Vermont Agency of Transportation
RECEIVED
Wardsboro BRF 013-1 (15) - Plate Girder comments #1.pdf
CK'D BY DRP OK'D BY CWC
February 1, 2016
RESUBMIT YES Rejected
BY C. CARLSON DATE 02/08/2016

DESCRIPTION: GENERAL NOTES

STRUCTURE: VT ROUTE 100 OVER WARDSBORO BROOK BRIDGE NO. 68
WINDHAM COUNTY, VT

LOCATION: TOWN OF WARDSBORO
PROJ NO. STATE PROJ. BRF 013-1 (15)
CUSTOMER: RENAUD BROS., INC.

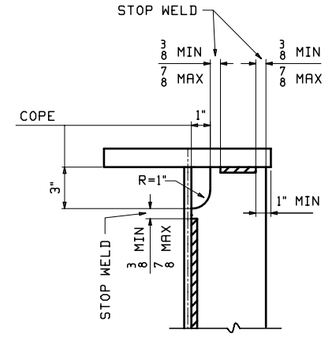
PER VT SPEC, THIS NEEDS TO BE SSPC-SP10

#470 IS NOT ACCEPTABLE FOR THIS WELD ON 50W STEEL

IS THIS SUPPOSED TO BE #480??

ONE ~ GIRDER ~ 1G1

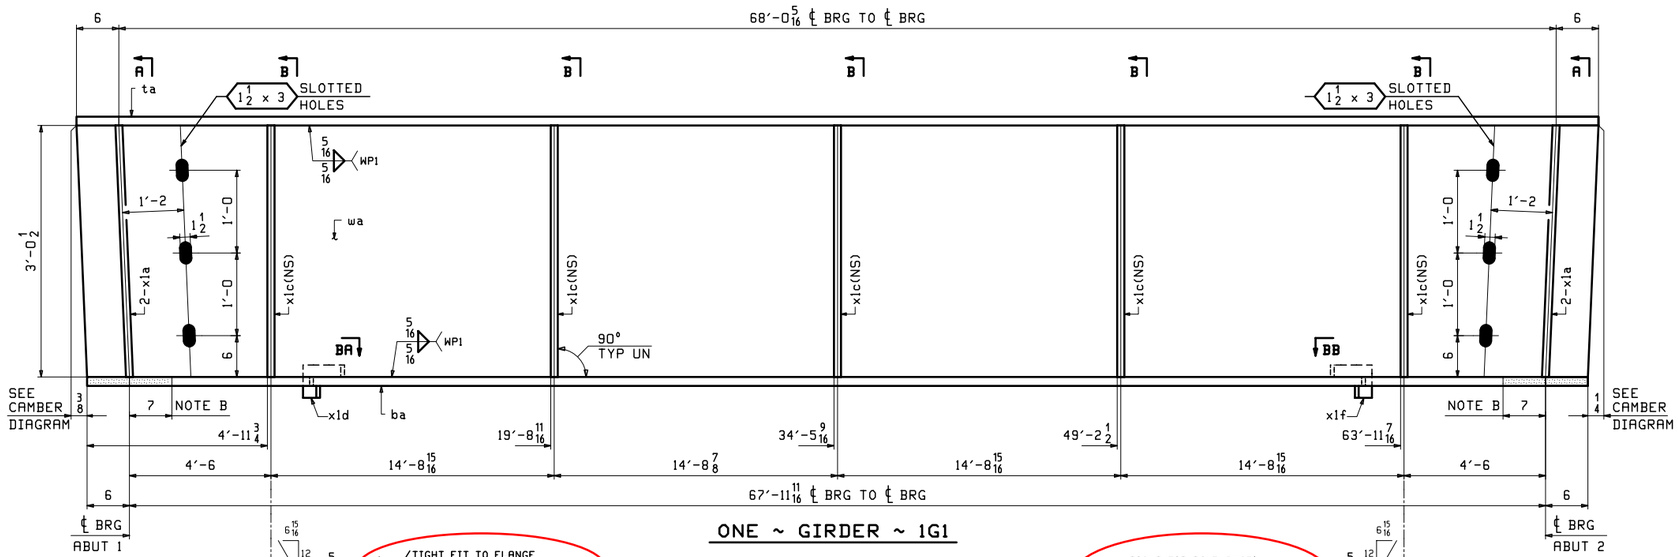
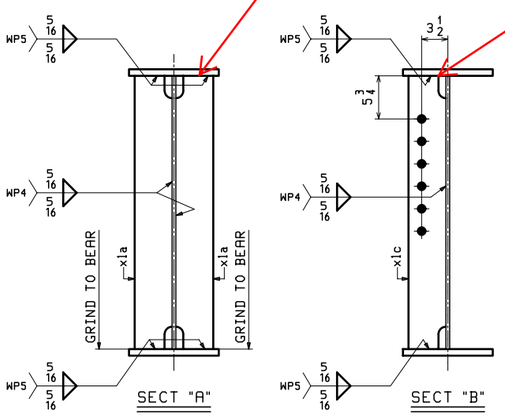
IF WPS #470 IS USED, FILLET SIZE IS LIMITED TO 1/4" MAX. IS WPS #480 THE INTENDED PROCEDURE?

ONE ~ GIRDER ~ 4G4

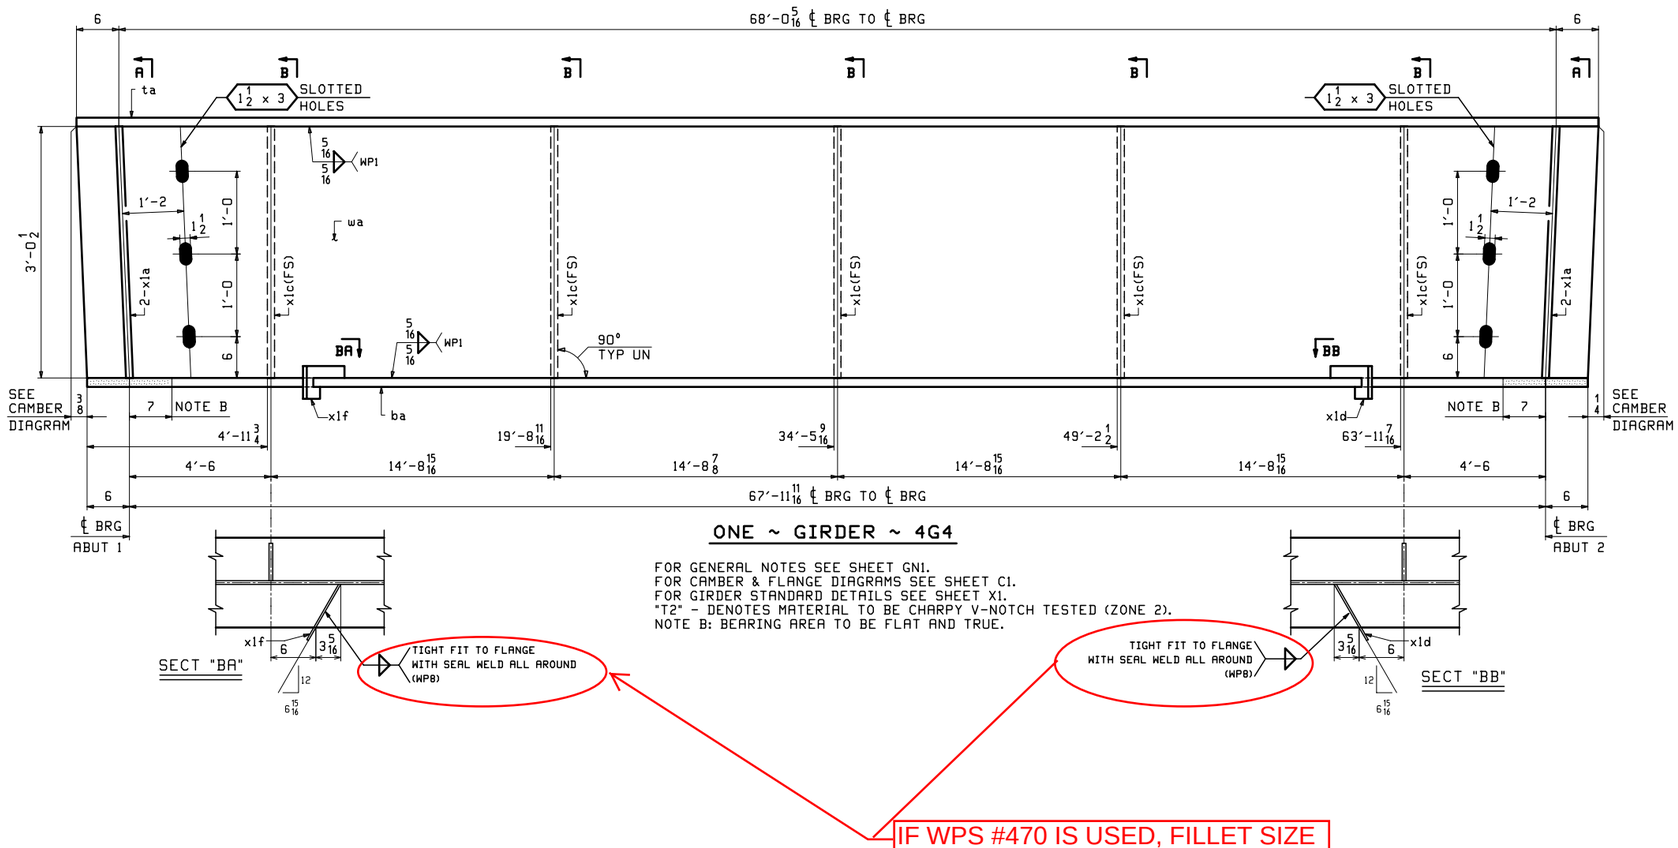
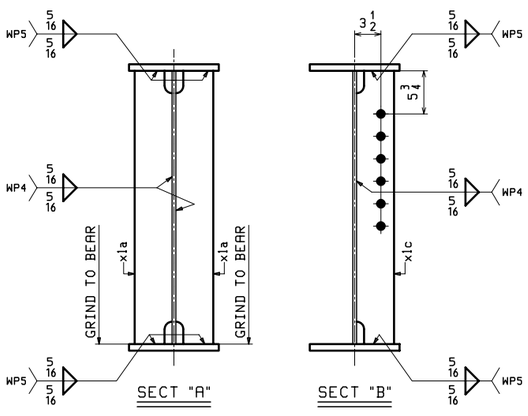
IF WPS #470 IS USED, FILLET SIZE IS LIMITED TO 1/4" MAX. IS WPS #480 THE INTENDED PROCEDURE?
